Access Compliance Report

Public Rights-of-Way

Intersection ID: 4257	Main Street: DAVID_COX_RD	Cross Street: WESTBURY_LAKE_DR	Location: E
ADA ID: 0F9234971B52	Ramp Type: Para	Initial Pass/Fail: Fail	Overall Compliance: No
			Severity Score: 48.75

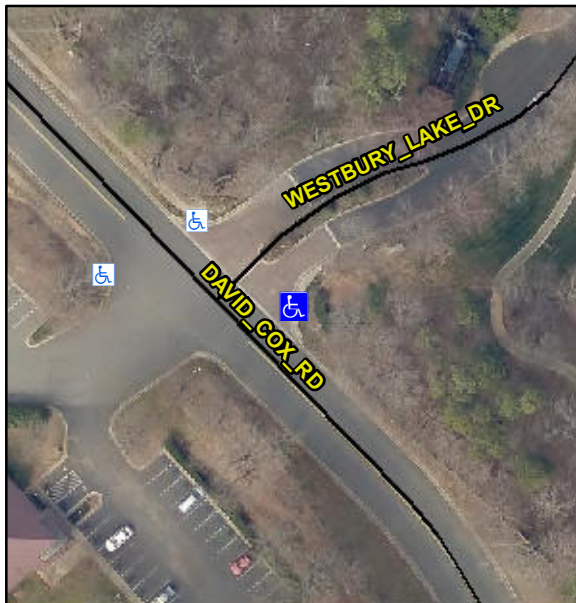
Surveyor Notes:

RT RP < 5%

PROW/ADA:

R304.5.1, R304.3.2, R304.5.3

Compliance	Description	Data	Compliance	Description	Data
N/A	Ramp Length LT (in)	48.0	N/A	Ramp Length RT (in)	48.0
No	Ramp Width LT (in)	31.5	No	Ramp Width RT (in)	28.5
No	Ramp Slope LT (%)	11.3	Yes	Ramp Slope RT (%)	3.6
No	Ramp XSlope LT (%)	2.8	Yes	Ramp XSlope RT (%)	1.6
N/A	Landing Length (in)	N/A	N/A	DWS Provided?	N/A
N/A	Landing Width (in)	N/A	N/A	DWS Contrast?	N/A
N/A	Landing Slope (%)	N/A	N/A	DWS Length (in)	N/A
N/A	Landing X Slope (%)	N/A	N/A	DWS Full Width?	N/A
N/A	Landing Curb? (Y/N)	N/A	N/A	DWS Offset (in)	N/A
N/A	Shared Landing?	N/A			
N/A	Gutter Ponding?	N/A	N/A	Gutter Slope (%)	N/A
N/A	Gutter Lip Ht (in)	N/A	N/A	Gutter X Slope (%)	N/A
N/A	Painted X Walk1?	No	N/A	Painted X Walk2?	N/A
	X Walk 1 Direction	To NW		X Walk 2 Direction	N/A
N/A	X Walk 1 Width (in)	N/A	N/A	X Walk 2 Width (in)	N/A
	X Walk 1 Slope (%)	10.0		X Walk 2 Slope (%)	N/A
	X Walk 1 X Slope (%)	1.4		X Walk 2 X Slope (%)	N/A
N/A	Ramp inside XWalk1?	N/A	N/A	Ramp inside XWalk2?	N/A

Possible Solutions:

Remove & Replace Entire Ramp.
